INLAND WETLANDS COMMISSION
TUESDAY, November 9, 2021
ZOOM Meeting

SITE DEVELOPMENT PLANS FOR A PROPOSED COMMERCIAL GARAGE

1574 RIVERSIDE DRIVE (ROUTE 12)
THOMPSON, CONNECTICUT

LAYOUT & UTILITIES PLAN
PREPARED FOR
JJS UNIVERSAL CONSTRUCTION CO.
1574 RIVERSIDE DRIVE - THOMPSON, CT
MAP 55 BLOCK 65 LOT 14

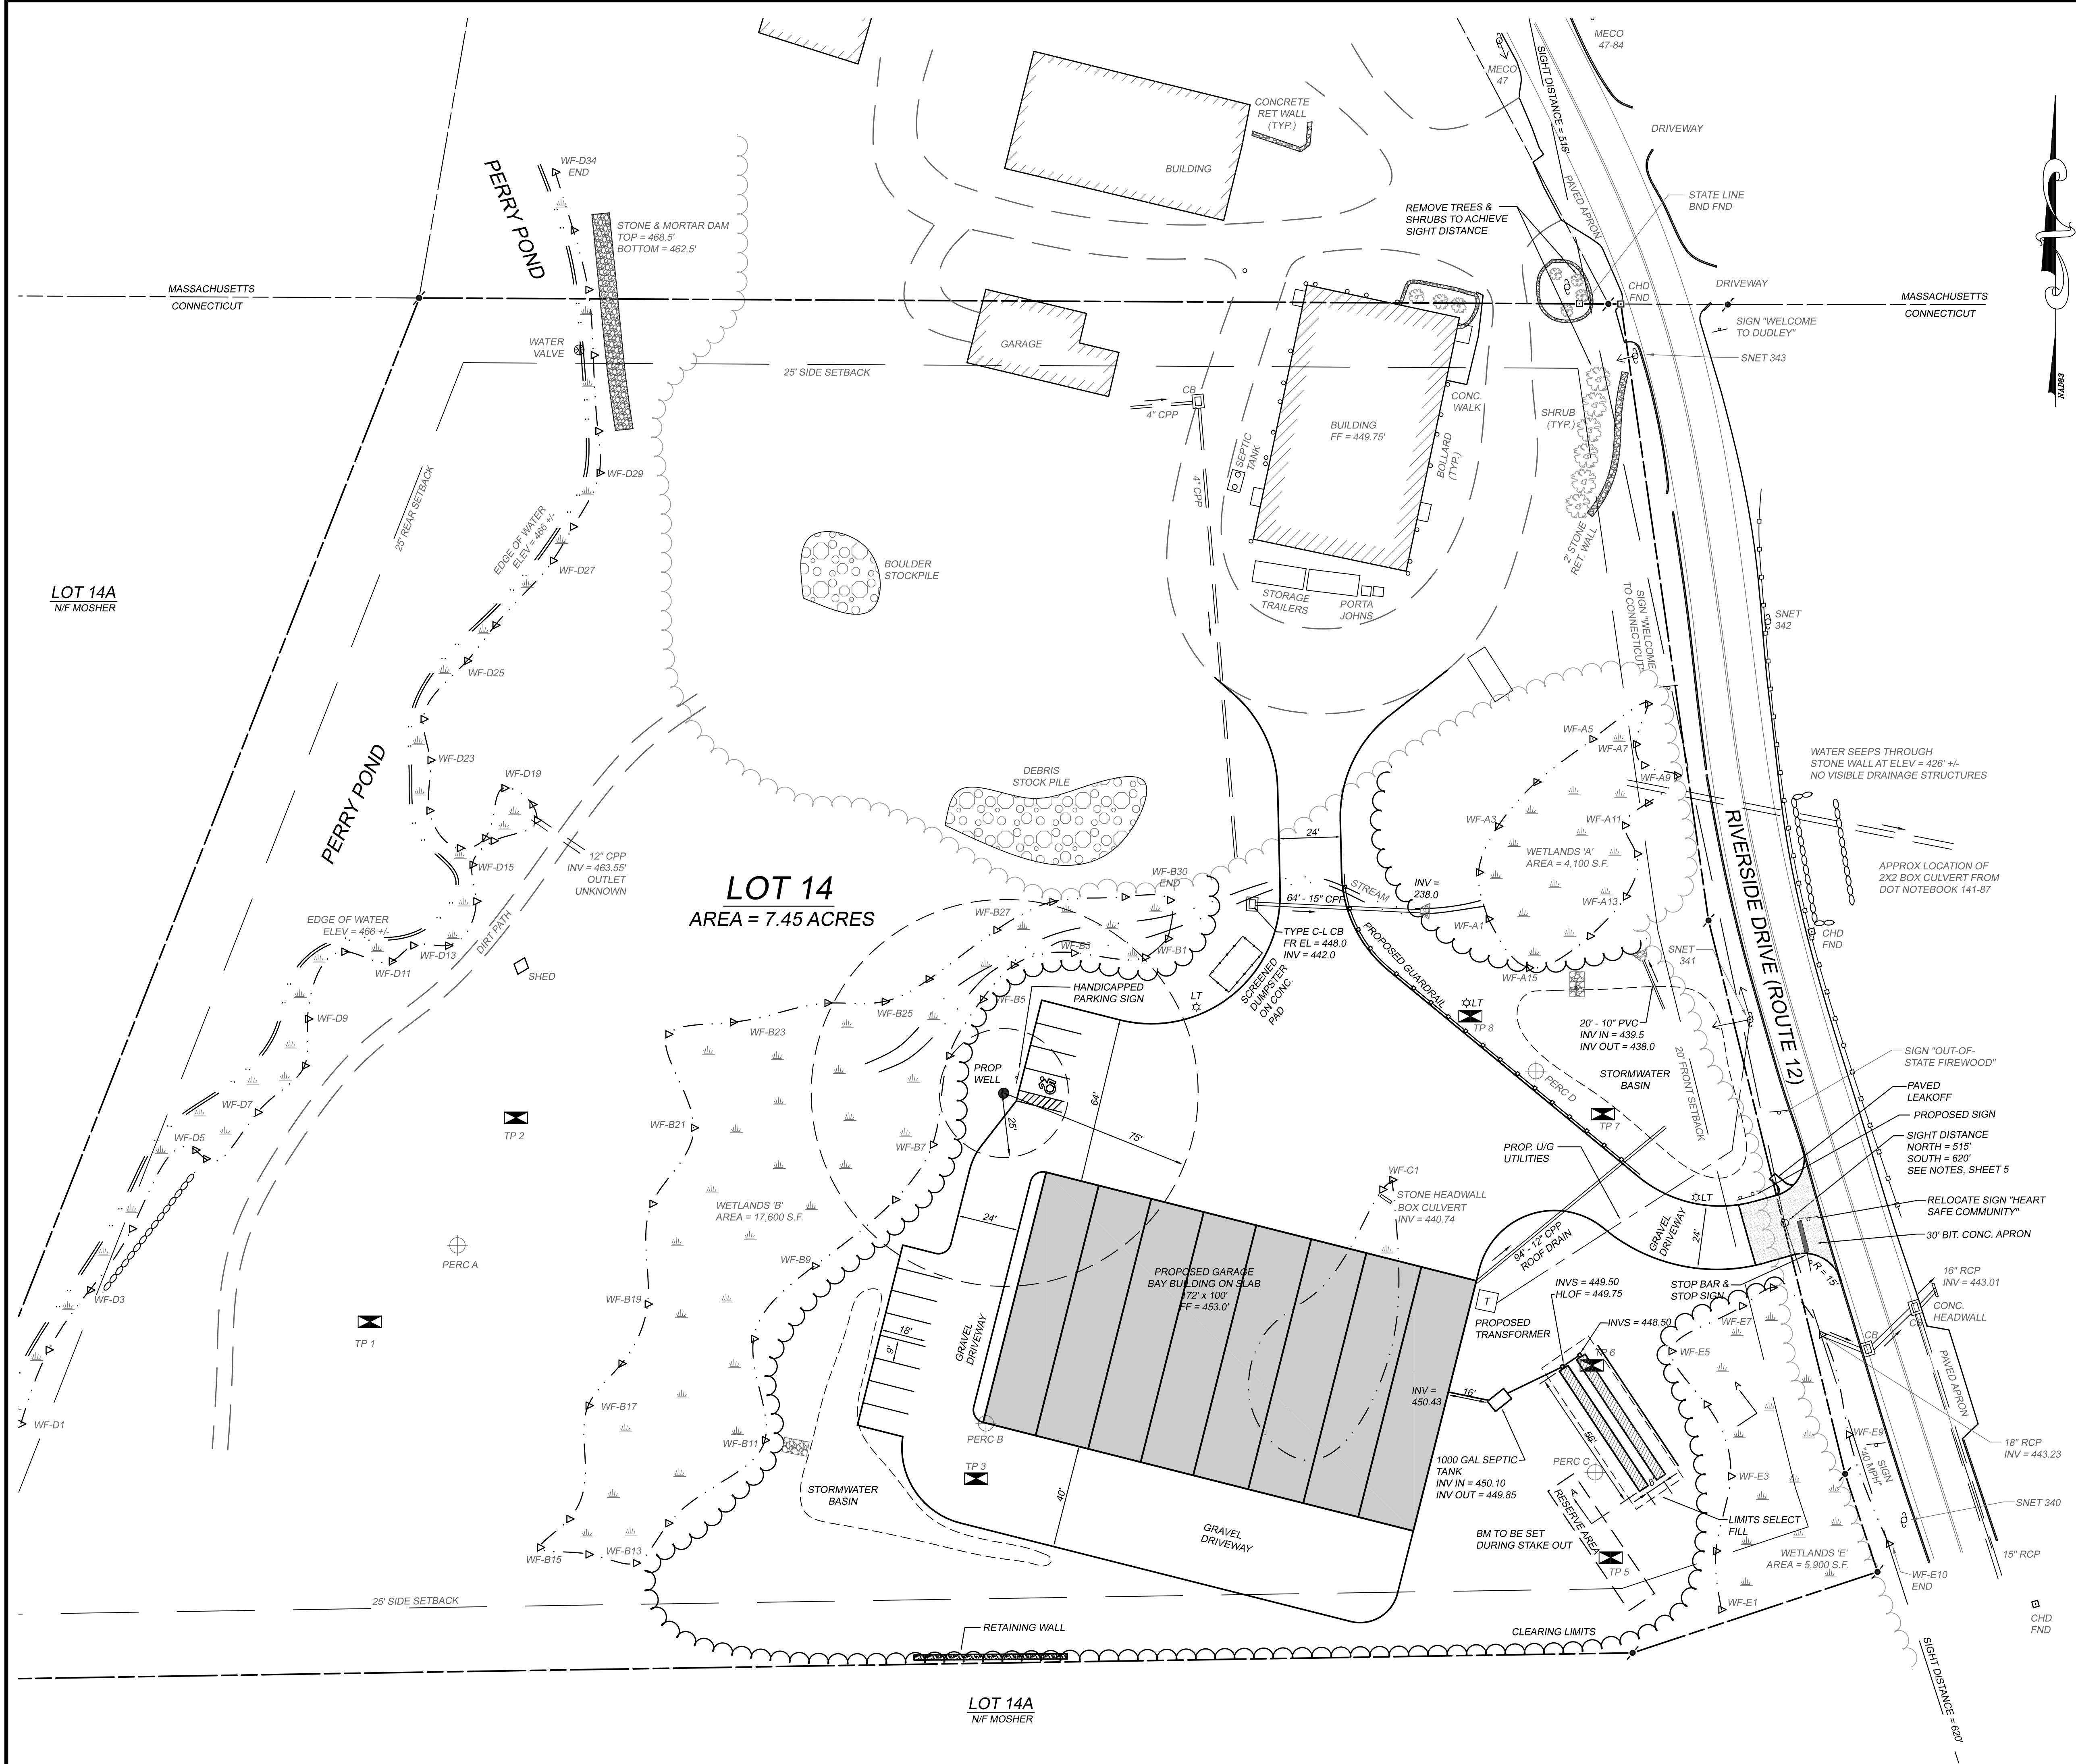
Commissioners met in the parking lot of the property and walked south towards the proposed building site, crossing a small stream where a catch basin/inlet is proposed. The Commissioners continued east towards test pits at a proposed stormwater basin, and followed along wetlands flags observed on the property, which were depicted on the site plan dated September 3, 2021. The Commissioners walked the area of the proposed structure and continued west towards Perry Pond, through the wetlands along the southern property line. Finding a trail, the Commissioners continued north towards the parking area. A partially obstructed outfall flowing east into the stream was discovered by the trail near wetlands delineation D17 by Chairman O'Neil.

The Commissioners continued the sitewalk along the stone and mortar dam and observed a flow of water on the Massachusetts side of the property which enters into a pipe by the dam and continues southeast through the Thompson property. The route on depicted the plans assumes the pipe outfall to be at the stream. The Commission traced the route through the parking lot, but was unable to locate the outfall.

Map Points of Interest MPB Site Walk 10-18-2021 Application IWA210280

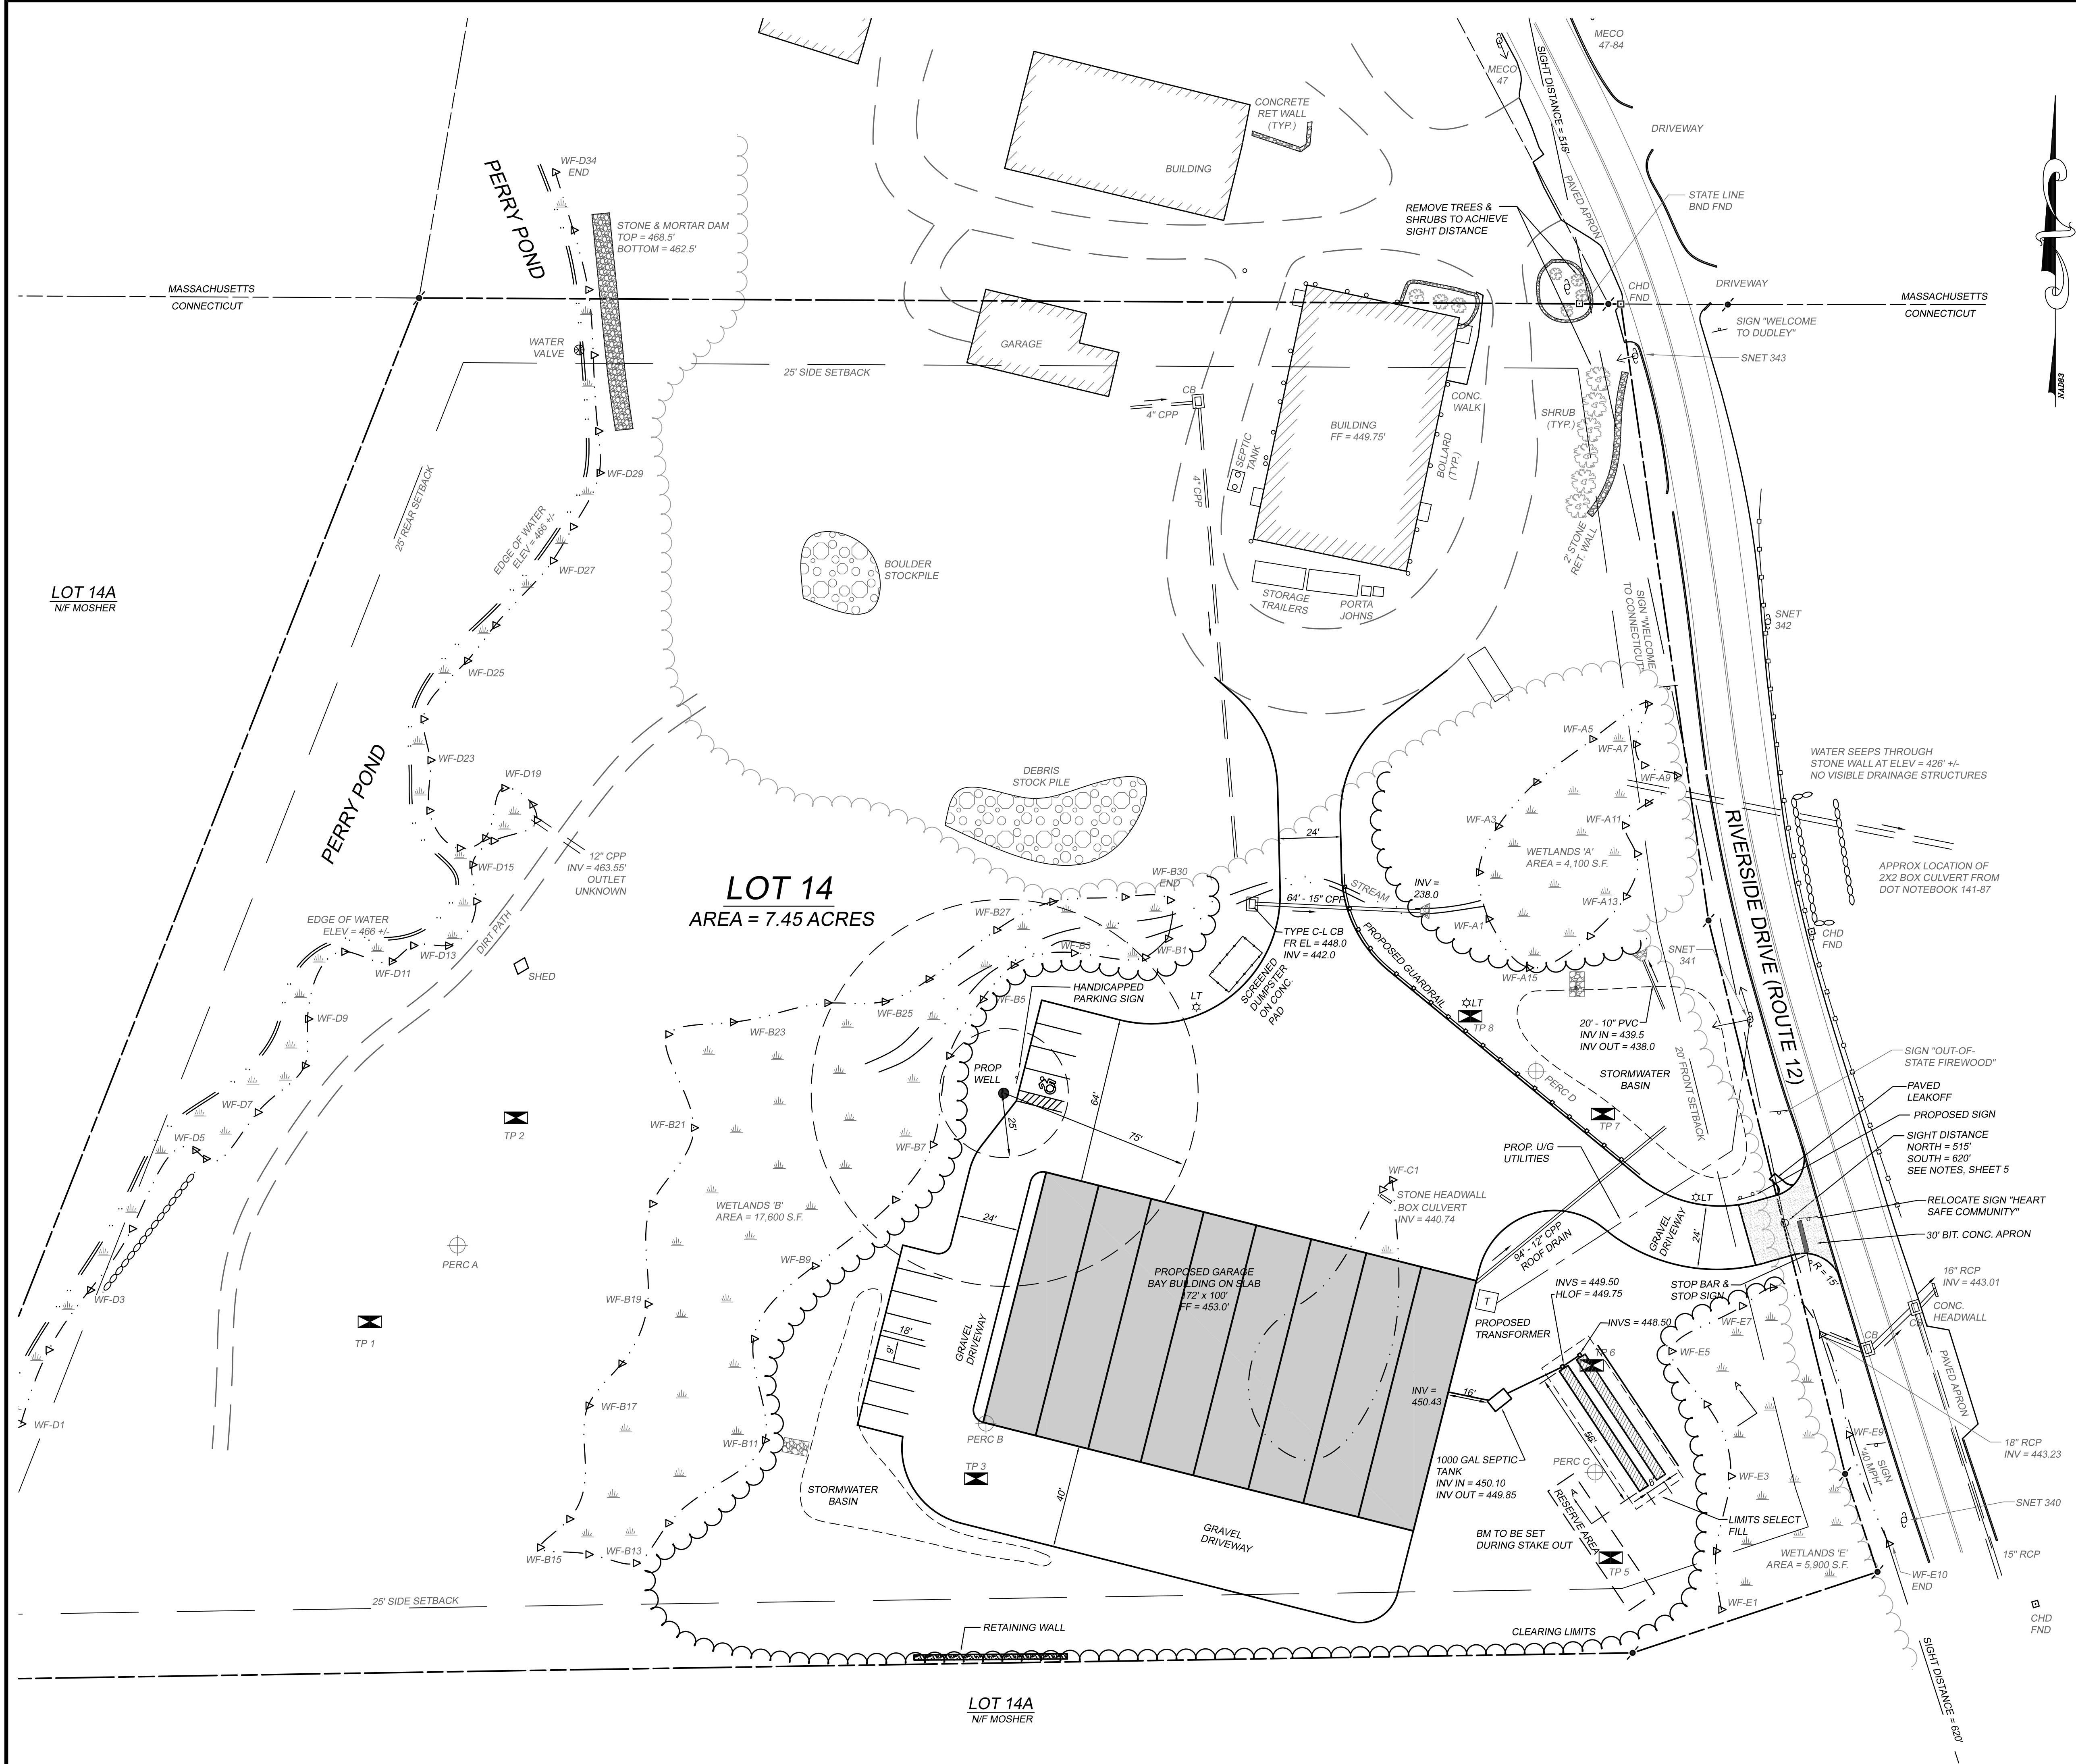
We began walking south from the existing "Building" crossing a small stream to a point identified on Sheet 2 where a catch basin/inlet is proposed (invert elevation 442.0, my map #1A). Note that Sheet 2 shows that an existing 4" CCP is also terminating in this area but the outfall was not observed. We continued southward to the wetlands proposed to be filled (C series wetlands). We found the stone headwall and culvert located at the northeast end of the wetlands (my map #1B). We then walked west to the southern end of the B Series Wetland and continued westerly reaching the dirt path that generally ran parallel to the east side of Perry Pond (see Plan Sheet 2).

At or about Wetlands Delineation D15 (just after the "shed") we observed what appeared to be a potential over flow channel coming from Perry Pond (my map #2). At Wetlands Delineation D17 (my map #3) looking west from the dirt path we observed water flowing from the base of the slope but did not see either a culvert outfall or inlet (Plan Sheet #2 references inlet invert at 463.55, outlet unknown).

Reversing our steps to the blue pipe, we then travelled south and observed a masonry structure that appeared to be a spillway of sorts constructed between two outcrops of ledge (identified on Plan Sheet 2 as "Stone & Mortar Dam"). Looking east we could see water flowing from the toe of slope draining away from the dam but did not follow its path through the underbrush (my map #6). I did not observe the waterward side of this structure but Daniel reported that he thought he could see what might be a gate valve submerged below the water.

At this point we returned to the yard area and at the catch basin located between the Garage and Building (see Plan Sheet 2, my map #7) we could hear water flowing but could not see where it was coming from or where it was going to. The plans are absent any information as to the origin of this water.

You will note from Plan Sheet 2 that the dam is bisected by the state line – half of the masonry structure as well as the earthen embankment are located in Massachusetts. The portion in Connecticut is not shown in DEEP's list of registered dams and its hazard classification is unknown.

During our site walk we did not observe evidence of recent overtopping of either the masonry portion of the dam, the earthen embankment north of the masonry wall or the natural ground near Wetlands Delineation D15-D17. The engineering report makes no mention of the dam, its condition or as to how water flows from Perry Pond. It is clear that water is being discharged from Perry Pond into Connecticut but the extent is unidentified. Additionally, the hazard classification and functional condition of the dam needs to be assessed.

For these reasons I recommend you conduct a site walk.
